**State Water Resources Control Board
Eagle Mountain Pumped Storage Project (FERC Project No.13123)**

**Responses to Comments on
July 2010 Draft Environmental Impact Report (SCH #2009011010)
January 2013**

Figure FEMA-1: FEMA Digital Flood Insurance Rate Map.

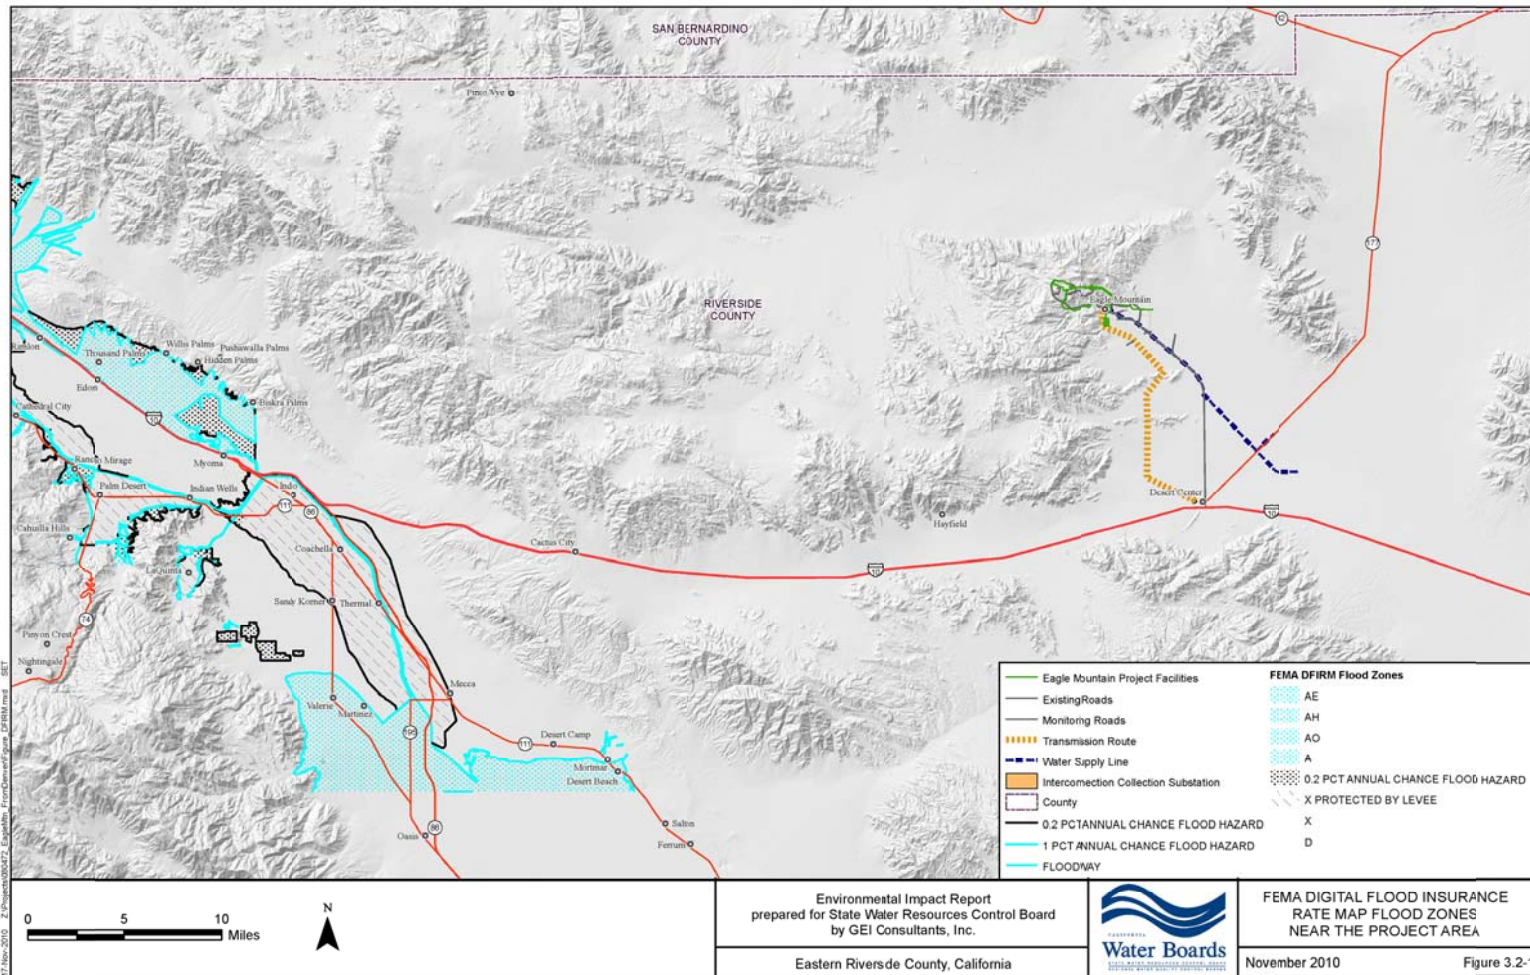
FEMA #1: Comment requests review of effective countywide Flood Insurance Rate Maps (FIRMS), County of Riverside (Community Number 060245), maps revised August 28, 2008.

Response to FEMA #1: As requested, the relevant maps were reviewed. The results of this review were reported in Section 3.3.1.3 of the Draft EIR.

The original (paper) Flood Insurance Rate Maps (FIRM) were never printed for the Project site and surrounding areas in Riverside County. A map showing the location of the proposed Eagle Mountain Pumped Storage Project (Project) is included below and in the Final EIR (Figure 3.2-1). The FIRM maps include a note that the entire area is in Zone D. Zone D is described as: areas with possible but undetermined flood hazards. No flood hazard analysis has been conducted. Flood insurance rates are commensurate with the uncertainty of the flood risk.

As shown on Figure FEMA-1, the Project is not within a Regulatory Floodway. Construction and operation of the Project as proposed does not have potential to contribute to a rise in base flood levels.

Figure NPS-1: Comparison of Estimated Annual Recharge to the Chuckwalla Aquifer as Developed by Various Authors.
 (For reference, 12,700 AFY is used in the Draft EIR.)

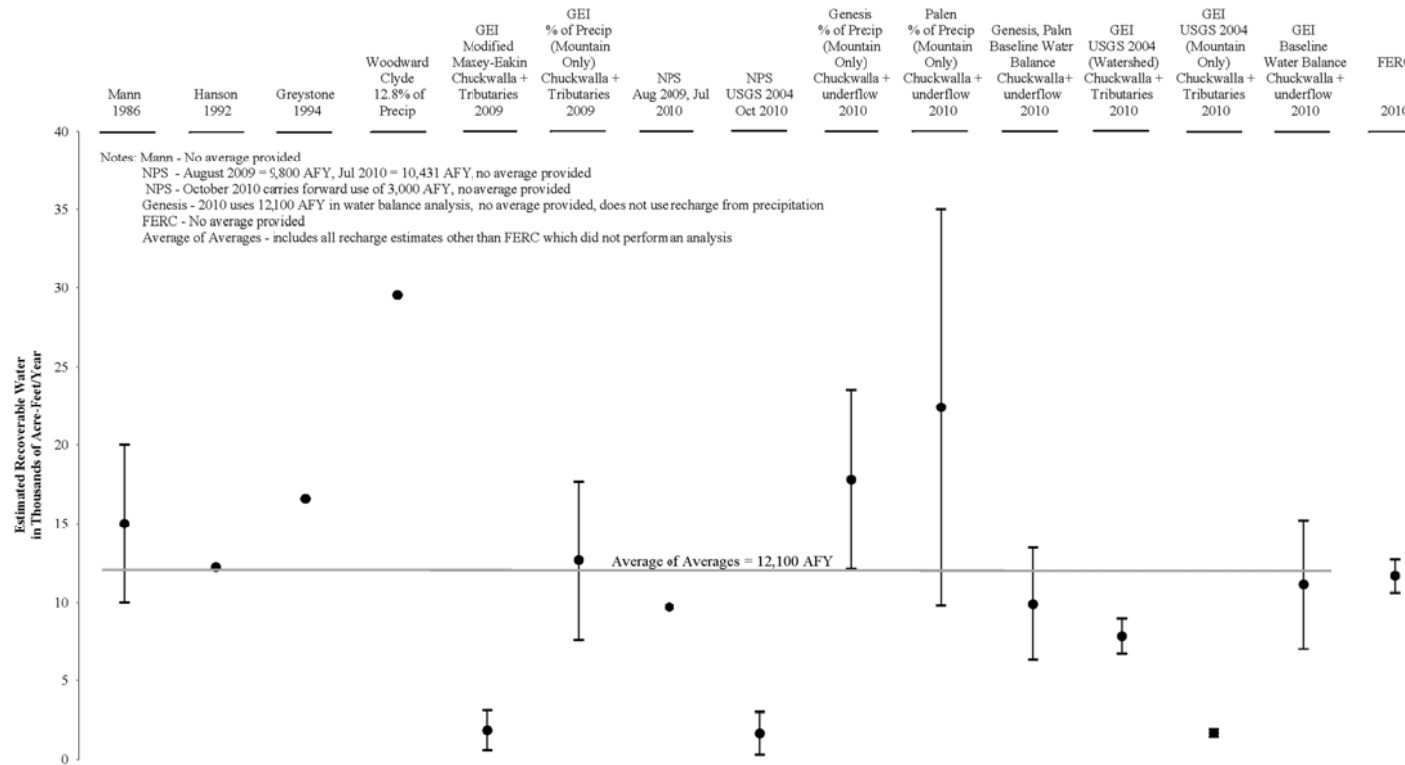
NPS #14-18: In the discussion on the results of the MWD Review Panel method, it was stated that the estimation of recharge was accomplished using the local precipitation-elevation curve for the Fenner Basin and recharge infiltration percentages of 3%, 5%, and 7%. This method produced total annual recharge estimates for the three proposed project basins ranging from 7,600 to 17,700 acre-feet, with a mean of 12,700 acre-feet. Examination of Figure 3 in Attachment F (Recoverable Water Estimates) of Section 12.4 shows three precipitation-elevation curves that can be used in this method: a local curve (Fenner Valley), a regional curve (region undefined), and a Western Mojave Desert curve. Given the Chuckwalla Groundwater Basin is generally situated in the western Mojave Desert, why was the Western Mojave Desert curve not used in the calculations?

It is apparent from Figure 3 [Figure NPS-1 in this document] that use of the local Fenner Basin curve in the calculations may be biasing the recharge estimates upward. No meteorological

Recharge to the Chuckwalla aquifer was estimated at 12,700 acre-feet per year (AFY) based on the calculations of the water balance described in Section 3.3.2.9 of the Draft EIR. This recharge estimate is near the mean estimate of recharge for the aquifer as developed by numerous authors. Figure NPS-1 shows a summary of groundwater recharge estimates for the Chuckwalla and tributary valleys using the estimates developed during previous studies. The baseline water balance estimates developed for NPS #14-5, use the United States Geological Survey (USGS) approach, NPS estimates from July and August 2010, recent recharge estimates used by state and federal agencies for the proposed solar projects in the valley, and previous estimates developed by this Project. As Figure NPS-1 illustrates, estimates of recharge for the Chuckwalla aquifer range from a low of 3,000 AFY as suggested by the NPS in its October 2010 comment letter, to a high over 30,000 AFY in the Palen Solar Power Project Draft EIS (BLM, CEC, 2010). The recharge estimates at the very low range of values would predict drawdown in the valley much greater than has been observed in groundwater levels. Therefore, these very low estimates of recharge are deemed inaccurate and unreasonable for use in water balance modeling. As shown in the graph in Figure NPS-1, the average of these estimates is

Figure NPS-1 shows a summary of groundwater recharge estimates for the Chuckwalla and tributary valleys including estimates developed by other authors including the NPS, estimates developed using the baseline water balance estimates developed for Response to NPS #14-5, estimates using the USGS approach contained in this response, recent recharge estimates from solar projects in the valley, and previous estimates developed by this Project. The average of the average of the range of estimates is 12,100 AFY (see Figure NPS-1). The estimate of recharge used in the Draft EIR was 12,700 AFY, which is well within the middle of the range of recharge estimates, indicating that the recharge estimate used in the Draft EIR was reasonable. Overall the conclusion of the Final EIR remains unchanged, that the potential impact of the proposed Project itself is less than significant, but cumulative impacts of all reasonably foreseeable projects are potentially significant.

Figure NPS-6: Well locations in Project area, revised from Figure 3.3-2 of the Draft EIR.

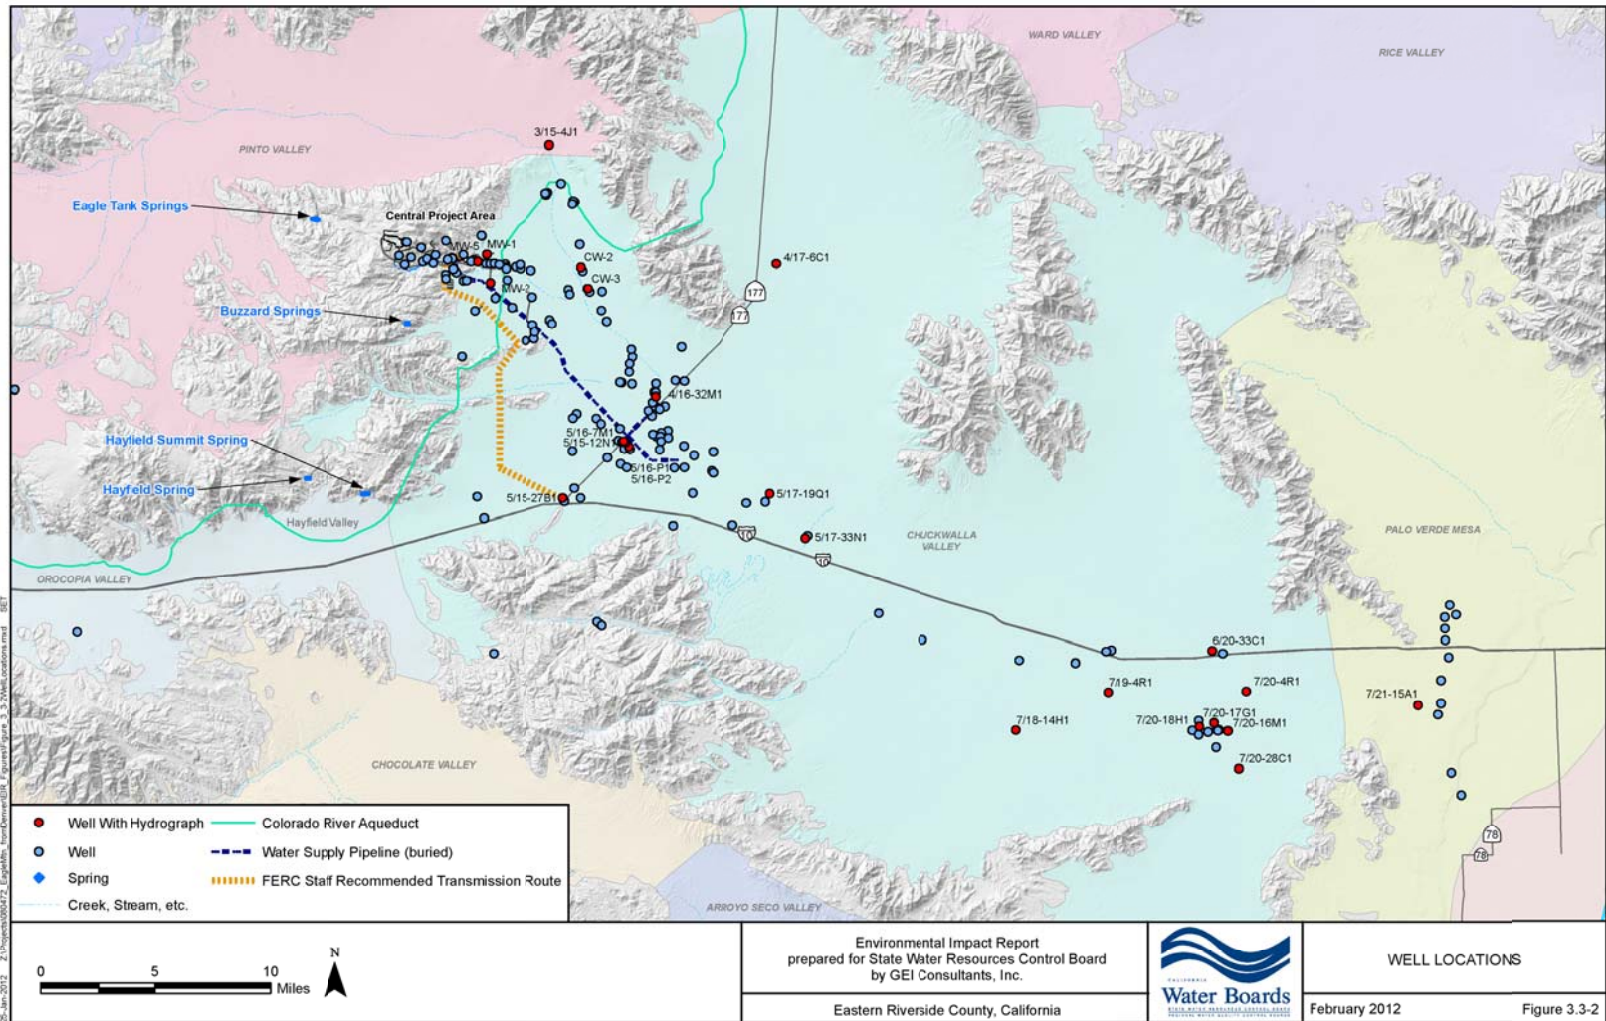
NPS #14-7: The NPS requests a table summarizing the water level information for all wells in the study area, and revisions to Figure 3.3-2.

Response to NPS #14-7: The Final EIR has been modified to include the requested information. Figure 3.3-2 of the Final EIR has been revised to show wells and the state well numbers for those wells that have a water level record. The revised Figure 3.3-2 is included in this response to comments as Figure NPS-6. The requested tabular information has been added to the Final EIR in Section 12.4 as follows:

Figure NPS-8. Cross Section B-B', Source: Wilson 1994.

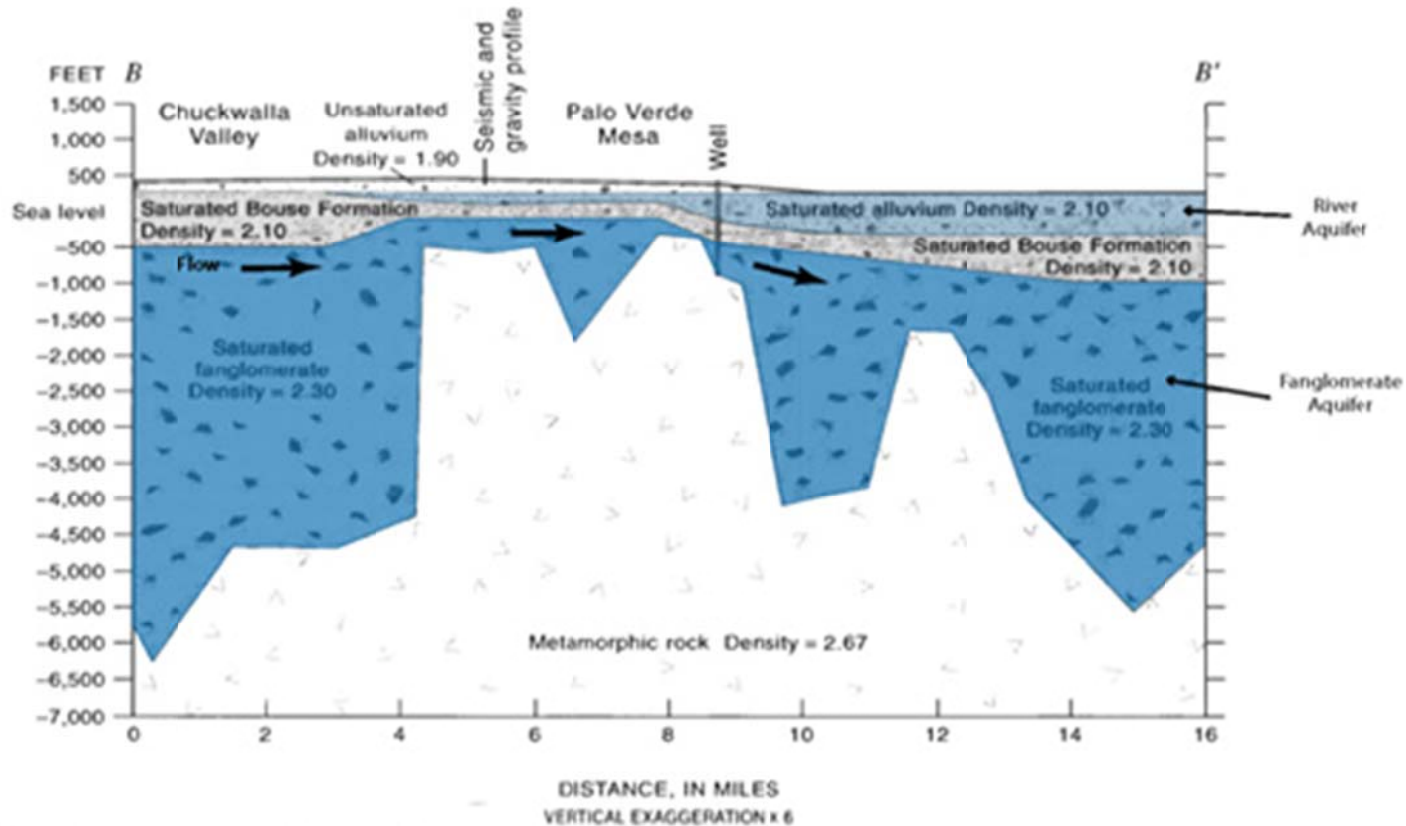
NPS #14-6: In the paragraph extending from page 3.3-6 to 3.3-7, the applicant contends that the Colorado River cannot recharge the Chuckwalla Groundwater Basin due to changing subsurface geologic conditions that exist in the region where the Chuckwalla Valley transitions into the Palo Verde Mesa Valley. The basis for this conclusion cannot be ascertained from the subsurface interpretation provided in geologic cross-section A-A' (Figure 3.3-4). The decision to lump the Pleistocene non-marine sediments (Bouse Formation?) and Quaternary alluvium into one unit (Qc) on the cross-section masks the subsurface conditions that are said to prevail. Additionally, there is no well on the cross-section in the Palo Verde Mesa Valley that supports the interpretation that has been presented. Please provide a more detailed cross-section in this transitional area of both basins that substantiates the interpretation of the subsurface conditions presented in the discussion.

If it exists, please provide a water level for the well located in the Hayfield/Orocopia Valley.

Response to NPS #14-6: See detailed cross-section in Figure NPS-8 (Wilson, 1994). Color and groundwater flow direction arrows have been added to the section to illustrate that there are two groundwater bodies, one associated with recharge by the Colorado River (the river aquifer) and an underlying confined aquifer that is separated from the overlying river aquifer by the clayey Bouse Formation which is almost impermeable (USGS, 1994). Groundwater flow arrows are from contours (DWR, 1975) and show groundwater from the Chuckwalla Valley would leave the area in the lower confined aquifer. The geologic sections were developed based on driller's well logs which describe the sediment types (clay, sand, gravel) but do not distinguish geologic units. To remain factual, only the sediment types were used to develop the geologic sections, to assess aquifer conditions and extent.

Although groundwater level data may not exist for the area, the bedrock (the bottom of the groundwater basin) is sloping toward the Chuckwalla groundwater basin, as shown on Figure 3.3-4 of the Draft EIR. Therefore, at least some portions of the Orocopia Valley groundwater basin, likely from the Chiriaco Summit eastward, are tributary to the Chuckwalla groundwater basin. All estimates of recharge were based on those portions of the Orocopia Valley groundwater basin east of Chiriaco Summit.
